**UPGRADE
BULLETIN:
200224REV**

**PRODUCT(S)
AFFECTED:**
American Coach
Dream, Eagle and
Revolution

SUBJECT:
Modifying the
Wire Harness
for the Keyless
Entry System

ISSUE DATE:
May 2020

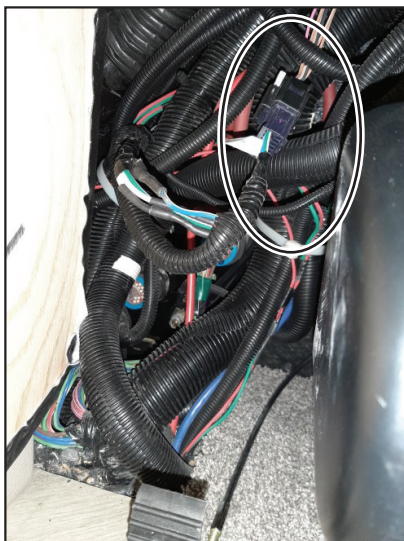
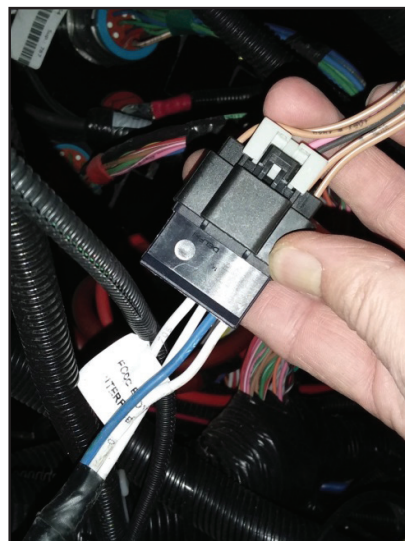
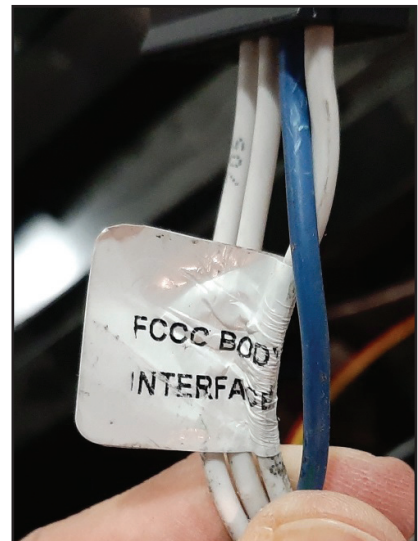
4. Turn off the ignition and remove the ignition key. Maintain control of ignition keys while work is performed. Attach a notice "DO NOT USE" to the ignition switch in order to avoid activation of the systems or starting of the motorhome.
5. Block wheels to prevent movement.
6. Locate and remove the black, vinyl wrapped access panel found to the left-hand side of the steering column, at floor level, see Figures 1 and 2.
7. In the area behind where the panel was removed, locate the OEM keyless entry connection near the steering column. It will be a 16-pin Packard connector with cavities A through D populated with the remaining positions empty. The harness will have a tag labeled "FCCC Body Builder Interface" near the connector and contain Circuits 088, 089, 705, and 706. See Figures 3-5 for clarifying information.

Figure 6

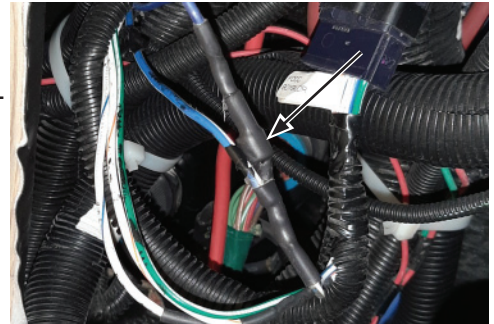
8. Once the correct connector and harness has been located, remove the wire loom and any tape from the harness approximately 6-8" from the connector in order to locate the diode connecting Circuit 089 (blue-white wire) to Circuit 053 (blue wire). See Figure 6.
9. If Circuit 053 (blue wire) has already been disconnected from the diode, take a clear photo and attach it to a draft claim. Submit using the inspection-only code listed on Page 4. If the Circuit 053 is still connected to the diode, proceed to the "Correction" procedures, Steps 10-14.
